Query 1 – details of continuous fit for purpose defence line at construction stage

River Wall Environment Agency Comments
WIE10667-103-BN-7-2-1-EA
WIE10667

RE: Stage Brewery – River Wall

I am writing in response to your objection dated 11th May 2018 in relation to the proposals for a new river wall at the Stag Brewery Site. Please see below the information for the removal of your objection.

| Project title Stag Brewery Planning | | Drawing number P10736-00-001-116 | | Client DARTMOUTH CAPITAL <small>Atkins House, 20-180 Spence Street, London E9 6JL</small> | |

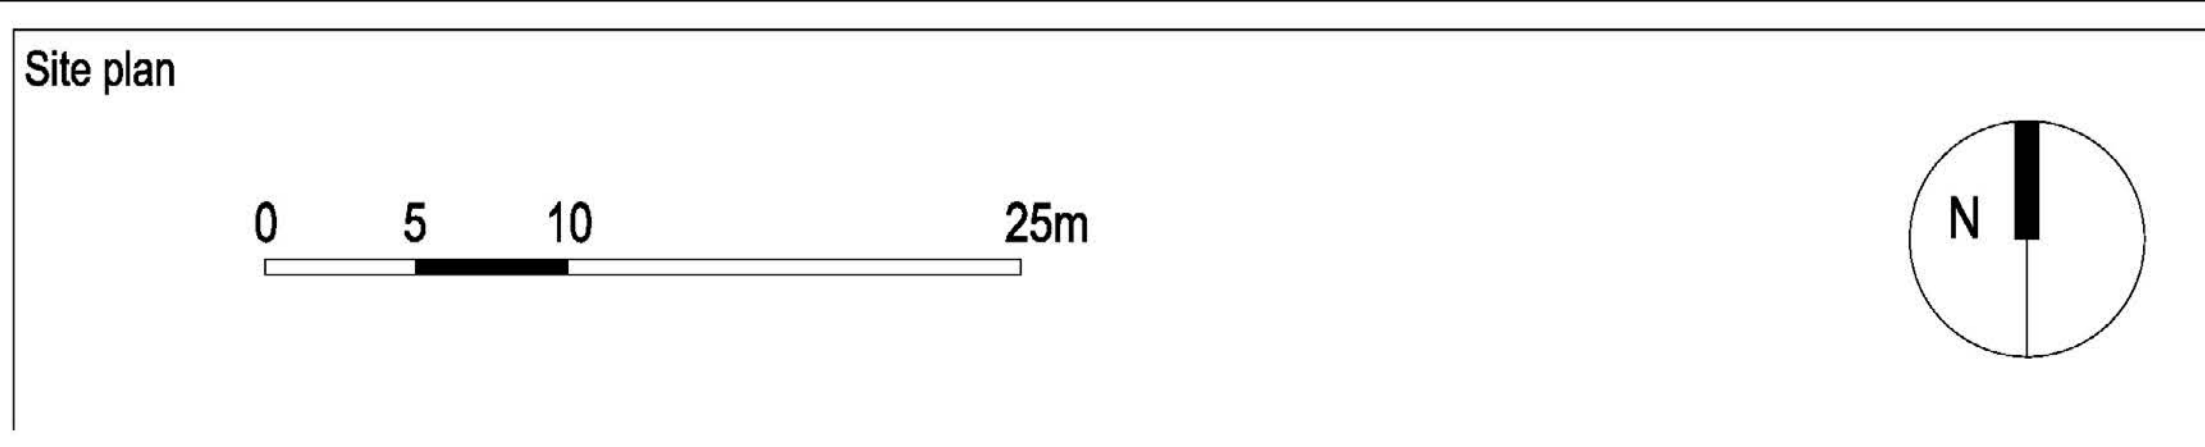
Query 5) – *The FRA includes reference to a minimum of 4m clear access route. Is the 4m between the new flood defences and development? Site Plans are also required clearly outlining the exact location of the new defence line including access arrangements and distances. It is also not clear what is being proposed for Ship Lane and Bull Lane. Details of the proposed flood gate barriers should be provided.*

Response – Please refer to the enclosed plan and sections prepared by Gillespies (Appendix A) which show the 4m minimum clear access route and offsets to defences.

Drawing:
BUILDING 09 - PROPOSED GROUND FLOOR PLAN

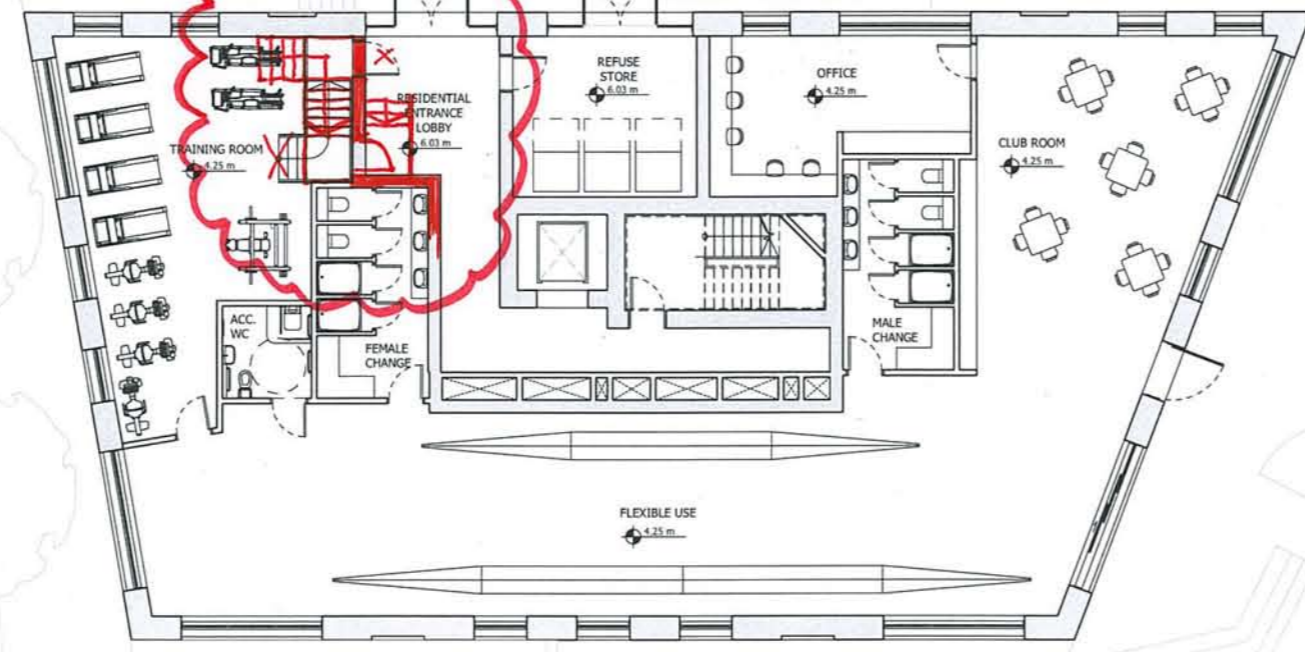
Drawing 38262/5501/062 illustrates the boathouse building on the eastern end of the site incorporates windows and internal access point below the TE2100 level within the flood defence line. The finished floor levels in the lobby/entrance area of the boat house are proposed to be set at 6.03m AOD, but the boat house finished floor level is to be set at 4.25m AOD. Details of how access will be achieved from the landward side of the flood defences into the boathouse will need to be provided

We will require cross section drawings of the boathouse and demonstration of how TE2100 levels will be achieved. The flood defence line must be continuous and not contain openings such as windows and access points. Additionally it will need to be demonstrated that no utilises which could compromise the defence line and integrity of the river wall structure.

AMENDMENT
TO ESCAPE STEPS FROM
BOAT CLUB, THROUGH
RESIDENTIAL ENTRANCE
LOBBY. TOP LANDING AT
ESCAPE DOOR TO BE RAISED
TO 6.7M A.O.D.

Title **THAMES RIVER WALL CONCEPT DESIGN**

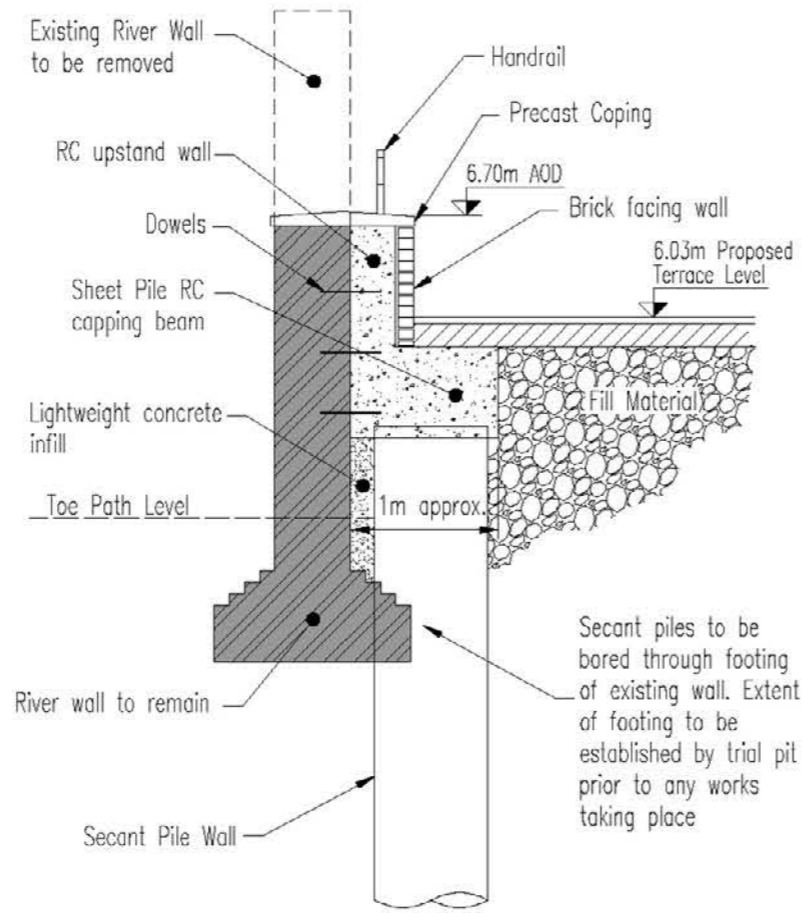
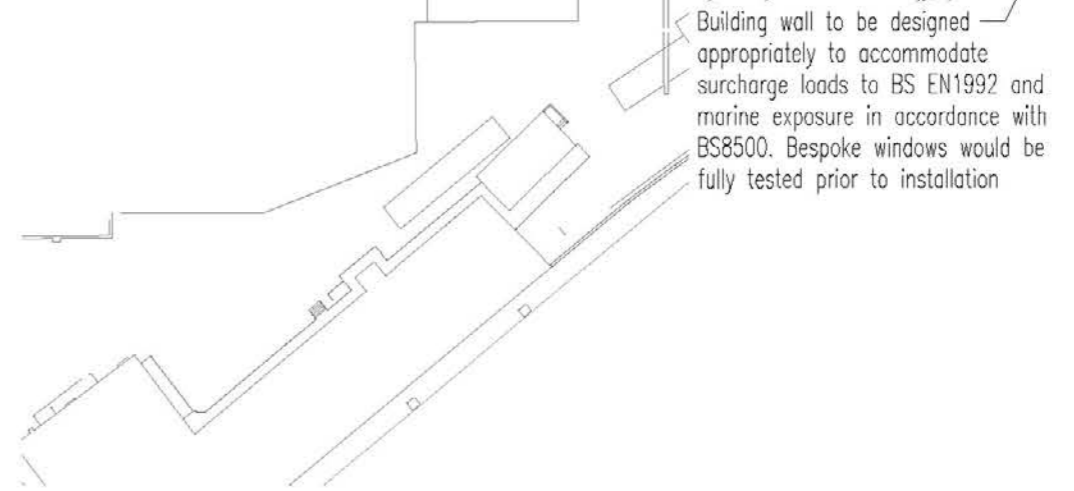
Query 1) – Details of how a fit for purpose flood defence line at the statutory level will be maintained during the construction phase (as previously conveyed at the meeting on 26 September 2016) and outlined in the FRA. Detailed method statements and sequence drawings for both temporary and permanent flood defences can be provided at the Flood Risk Activity Permit stage but we would like an outline Method of Work.

Query 3) – *We note that the new flood defence walls will have a crest level of 6.13m AOD and “topped by a 1.1m high glass balustrade, with effective crest at 7.23m AOD”. The applicant should demonstrate how TE2100 level can be achieved in future; if this additional raising is effectively the glass balustrade, then it must be demonstrated that this element is structurally sound as a flood defence component (i.e. will it be made from toughened glass to sufficiently withstand the calculated hydrostatic pressure as well as being watertight?).*

Response – The outline method of work and the design presented to date is based on the assumption that the new river wall is to be constructed behind the existing river wall, allowing for the existing flood defences to be maintained throughout the construction of the new wall. Therefore, in the temporary case, whilst the new river wall is being constructed, the existing flood defence will remain in place and serve as the flood protection in the area as it currently stands. The existing wall would then be reduced in height to match the new flood defence, set at the statutory defence level. The new river wall will only come into use once it is completed along the alignment shown in WIE-SA-04-1006 A04 (Appendix A).

Response – The main construction of the river wall would be either sheet pile or secant pile (to be confirmed at the detailed design stage). Where required to achieve the minimum defence height of 6.70m AOD, a glass balustrade/wall would be installed on top of the piled wall. The glass balustrade/wall would be a flood defence specific product, an example of which is provided in the enclosed document prepared by Hydro-Logic (Appendix B).

The flood defence would be raised to the full height of 6.70m AOD as part of the proposals, as required by the TE2100 Plan, no further raising would therefore be required. The construction of the crest of the defence would vary along its length, however would always be a minimum of 6.70m AOD. Please refer to the enclosed plans which shows the treatment of the river wall (Appendix A).

**STAG BREWERY, MORTLAKE
 POSSIBLE HIGHWAY LAYOUT - PHASE 1
 VEHICLE SWEEP PATH ANALYSIS FOR A
 SMALL MOBILE CRANE**

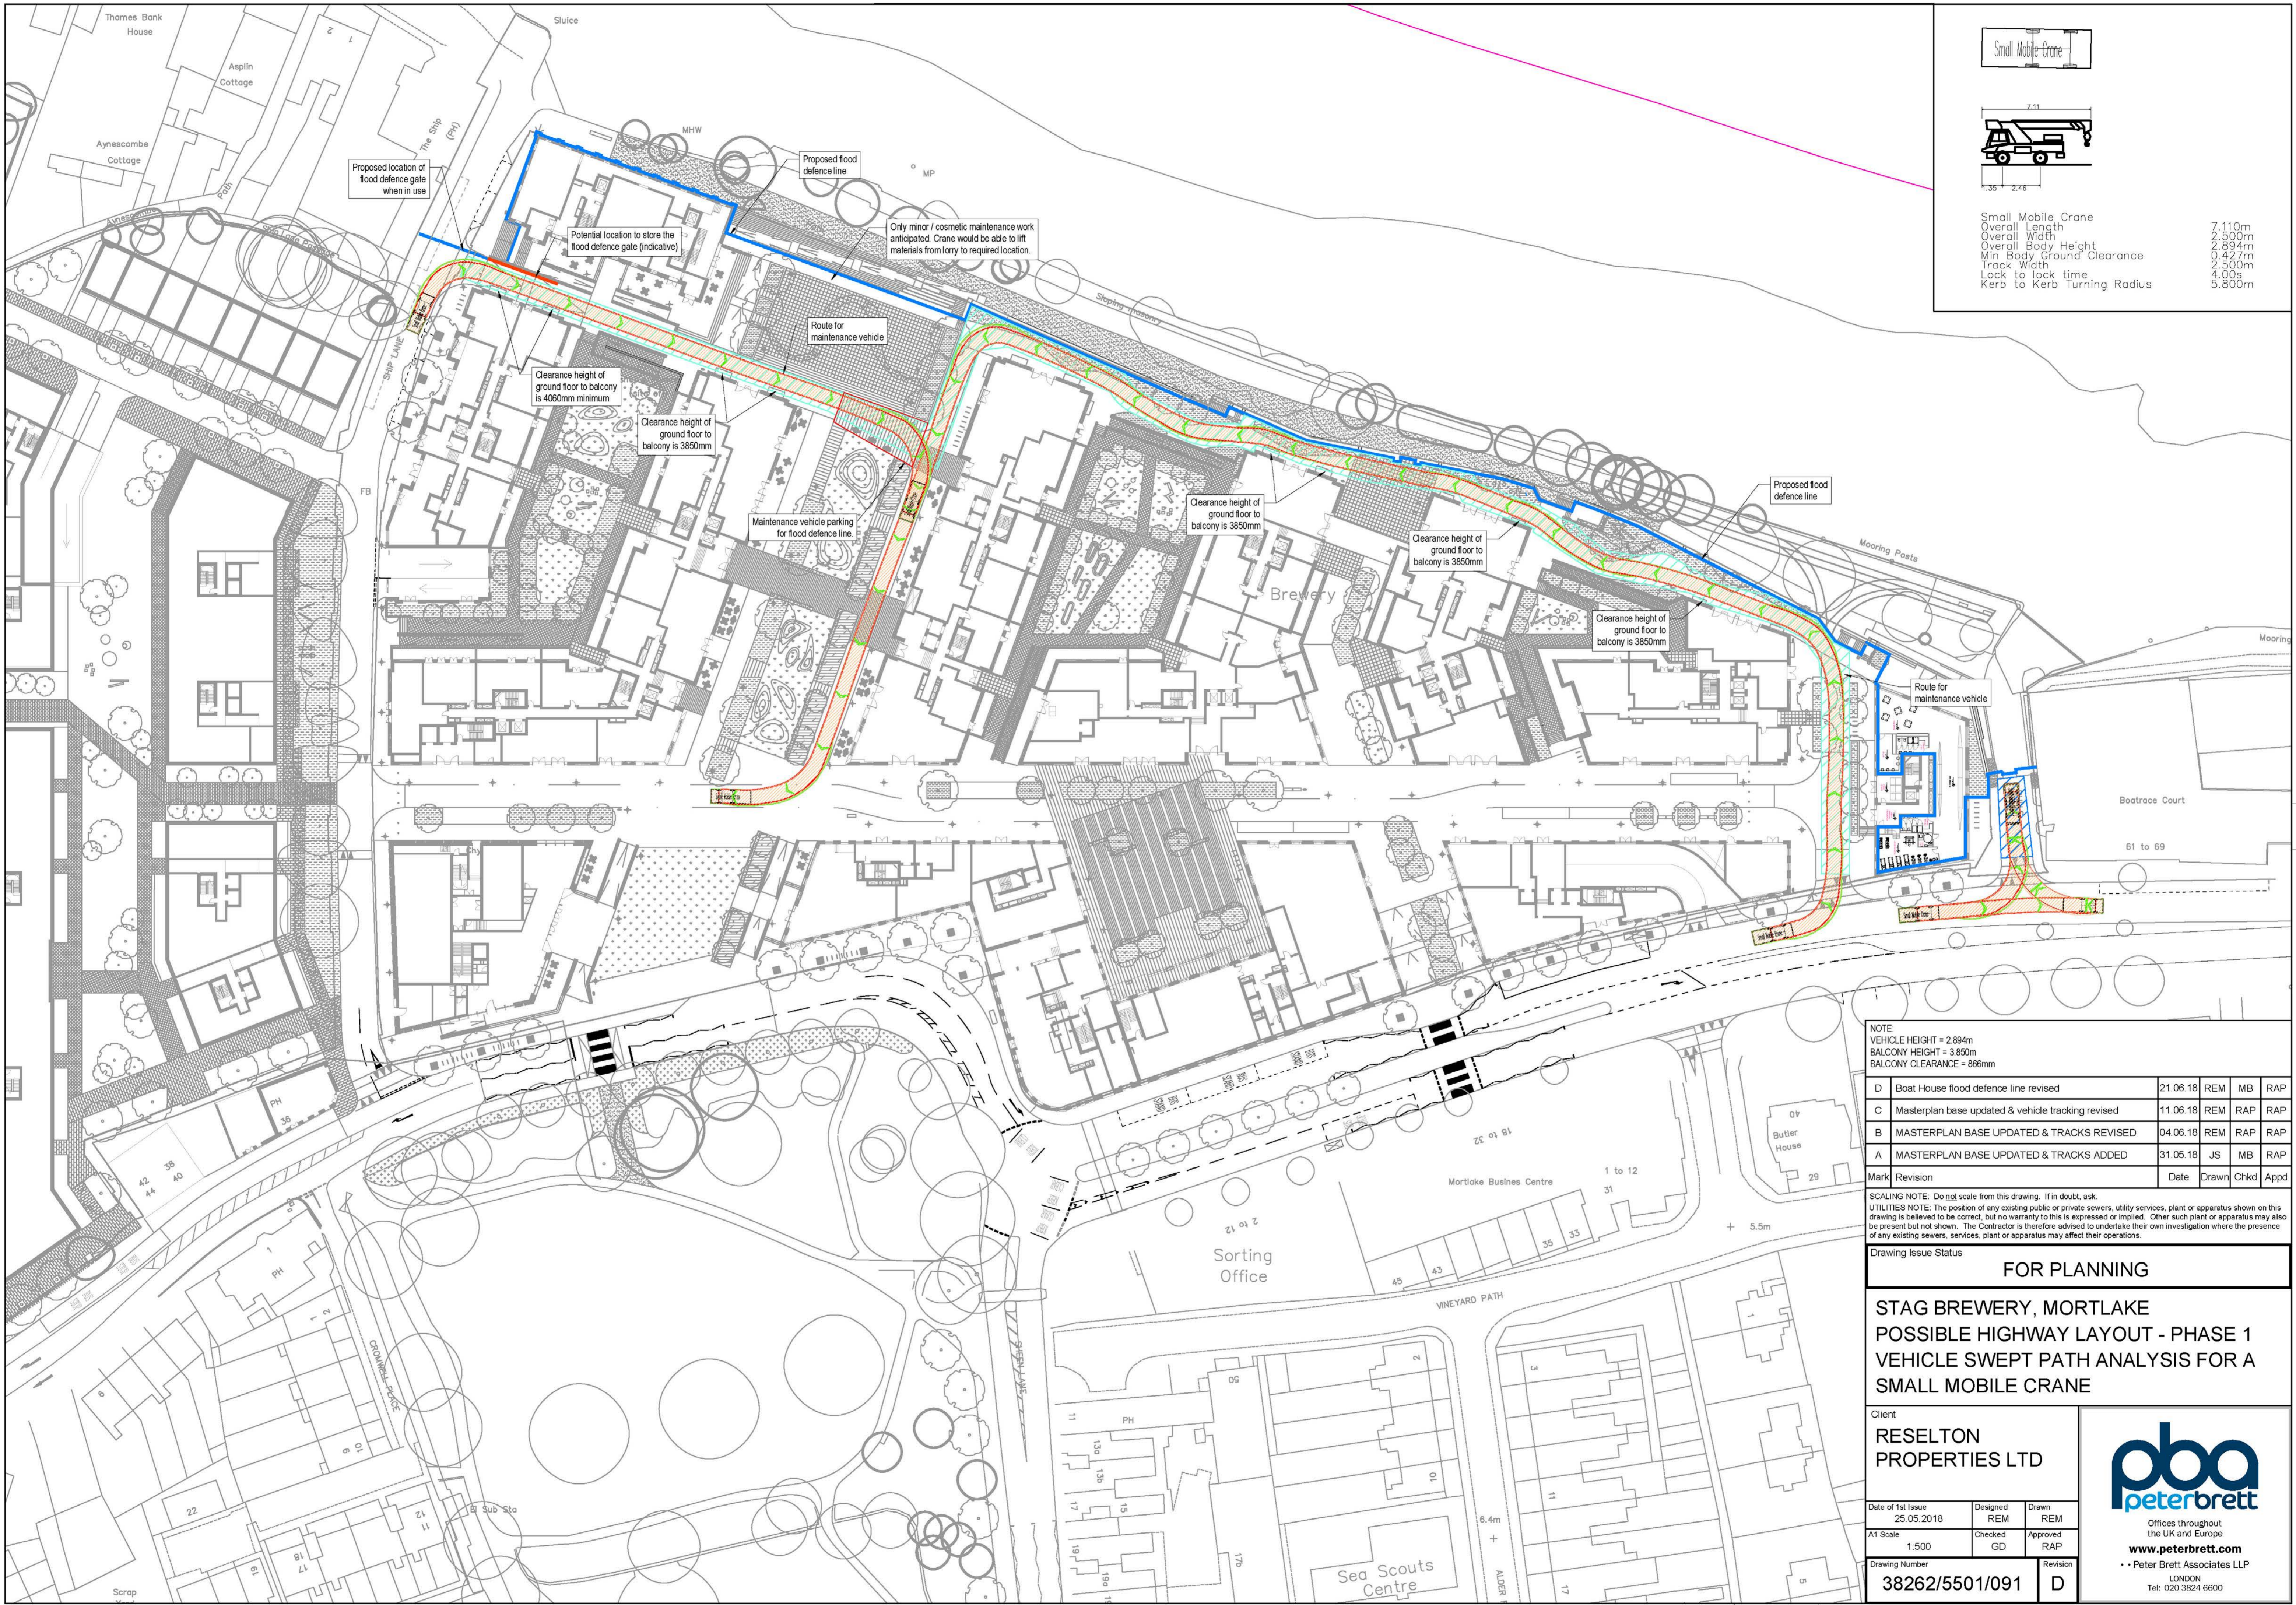
Drawing 38262/5501/062 illustrates a vehicle tracking plan for a 10m long lorry, however the circa 4m clearance height appears to be insufficient to actually operate any plant within these areas. Furthermore, the flood defence within the northwest corner of the site appears to be inaccessible. It appears that the applicant will use of the existing building as the defence line. Further information is required as to how the defence will be accessed from the landward side.

Query 4) – *A vehicle tracking plan should be produced to ensure the offset between the defences and built development is sufficient to allow plant unrestricted access for future works on the flood defences. The applicant should also note that vertical unrestricted access is also required, i.e. consider positions of balconies.*

Response – As set out above, the defences would have a design life of 100 years. This would remove the requirement for future piling to raise/maintain the defences during the lifetime of the development. The requirement for tracking is therefore based on maintenance rather than reconstruction. It is considered that given the piled construction of the defences any maintenance is likely to be minor/superficial. Please find enclosed drawings prepared by Peter Brett Associates (Appendix C) showing the tracking of a 10m Rigid Vehicle and a Small Crane. These vehicles are considered appropriate for maintenance works. In the location adjacent to the Maltings Building the vehicles would not be able to park directly adjacent to the river wall, however they would be able to crane materials into the appropriate location. The proposed tracking accounts for vertical clearance to balconies and tree canopies, ensuring vehicles can pass beneath unrestricted.

NOTE:
 VEHICLE HEIGHT = 2.894m
 BALCONY HEIGHT = 3.850m
 BALCONY CLEARANCE = 866mm
